# Evaluation of the AoR Delineation Modeling Approach for Wabash Valley Resources Class VI Permit Application

This area of review (AoR) delineation modeling evaluation report for the proposed Wabash Carbon Services (WCS) Class VI geologic sequestration project summarizes EPA's evaluation of the modeling performed by the Illinois State Geological Survey (ISGS) and Pacific Northwest National Laboratory (PNNL) as described in the Area of Review and Corrective Action Plan. This review also addresses modeling-relevant site characterization information in the permit application narrative. [Clarifying questions for WCS are provided in blue within the text below.](#)

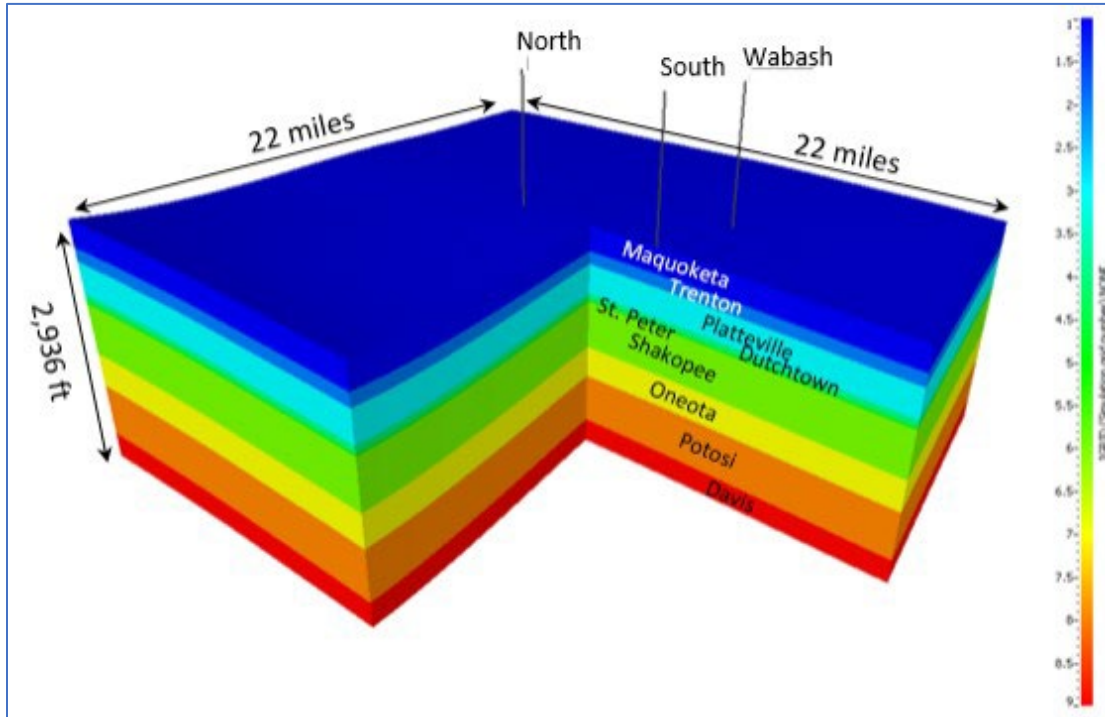
- The “Model Domain” section mentions the use of “47 vertical layers” and “241 layers.” Please explain the difference between the referenced numbers of vertical layers.
- The color bar in Figure 9 is not legible. Please revise the figure to include a legible color bar. Additionally, please describe the units being represented by the color bar.

**Figure 11. Permeability distribution in the static Petrel model volume. In a clockwise direction beginning with the northeast, the center coordinates of the corner cells in the model are: NE: -87.28467, 39.74204; SE: -87.288718, 39.428321; SW: -87.69399, 39.429763; NW: -87.692678, 39.744527.**

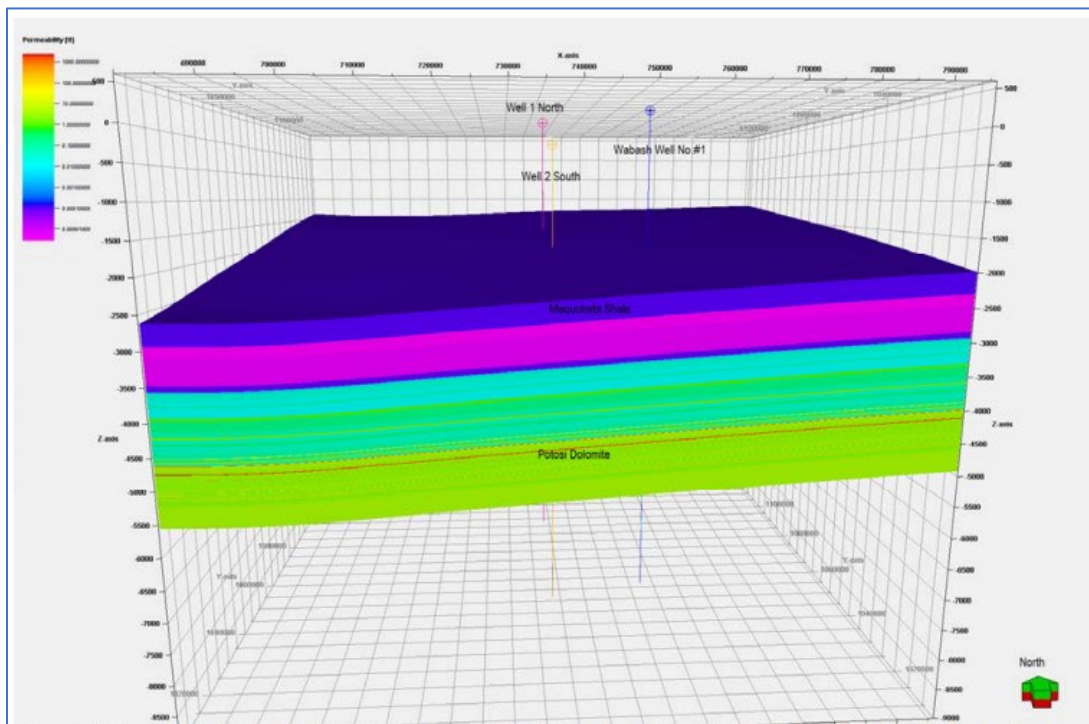
- Figures 11 and 12 of the AoR and Corrective Action Plan would benefit from labeling of the tops of the secondary shales that contribute to the 1,900 cumulative feet of confining zone to the extent possible. Please also clarify the resolution or enlarge the text of the legends in these figures.
- If available, please provide an isopach map for the Maquoketa Shale and or the Maquoketa group.

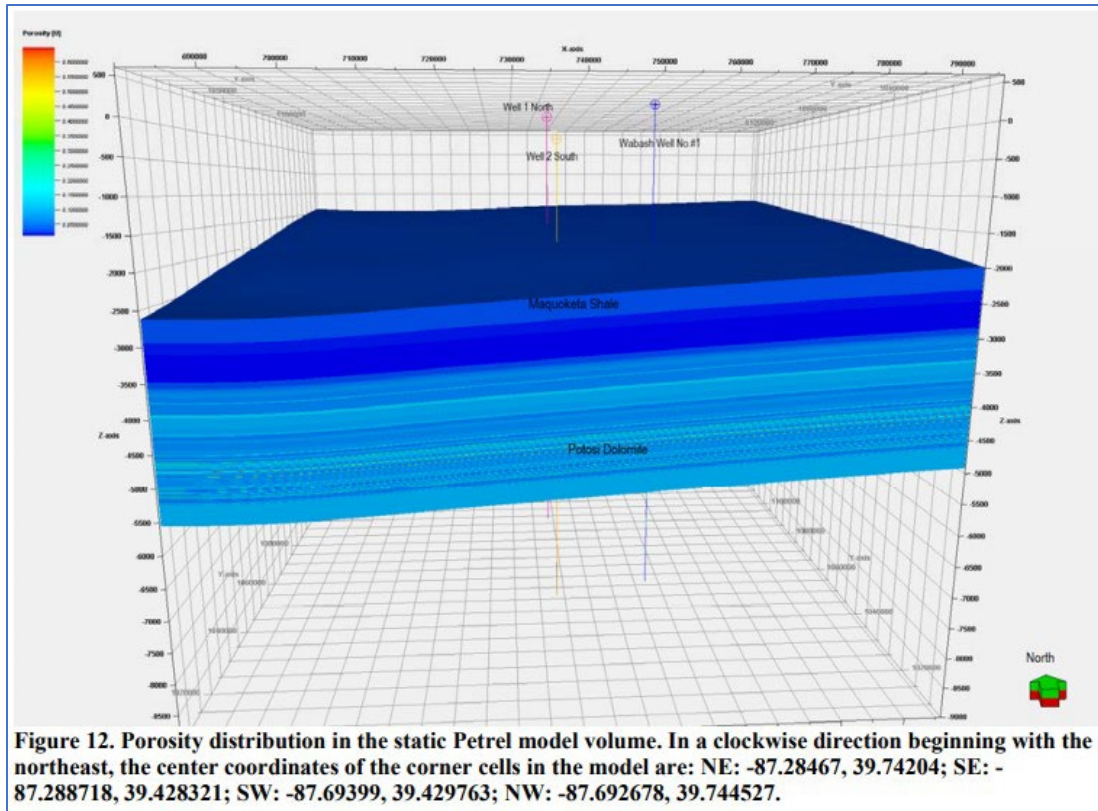
permeability values in Tables 1 and 2. The porosity distribution in Figure 12 could not be cross referenced with Tables 1 and 2 due to the low-resolution of the legend.

**Figure 13. Maximum plume distance from injection wells over time, based on a 1% CO<sub>2</sub> saturation cutoff. The late uptick in plume radius (after stabilization) is due to coarseness of the outer grid cells.**

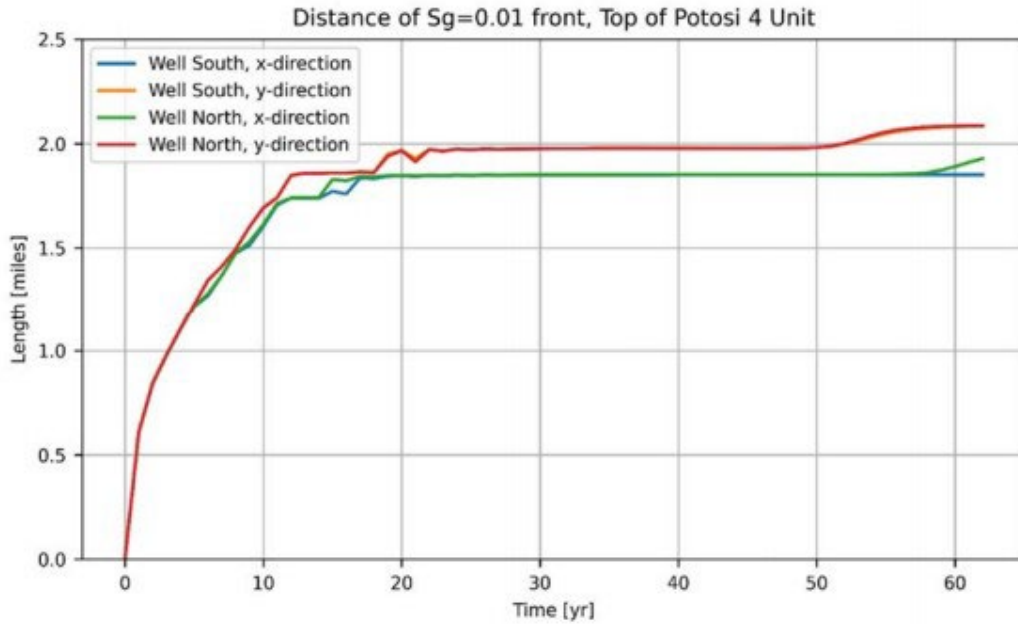
- The maximum lateral extent of the CO<sub>2</sub> plume is noted to be reached at year 62 (the end of the simulation period) and 16 years after injection begins (4 years after injection ceases). It is understood that the maximum lateral extent essentially is constant between years 16 and 62, however it is recommended that this section is clarified regarding the timing of maximum lateral extent cessation.
- Please explain the significance of a 1% CO<sub>2</sub> saturation cutoff used to determine the extent of the CO<sub>2</sub> plume for delineating the AoR.
- Please explain the early changes in slope (i.e., at year 12) demonstrated by the curves in Figure 13.
- Please clearly label the color bar and define units of measure in Figures 14, 15, and 16.
- Please label formation depths/tops in Figures 15, 16, and 17 in cross-sectional views of the predicted CO<sub>2</sub> plume.
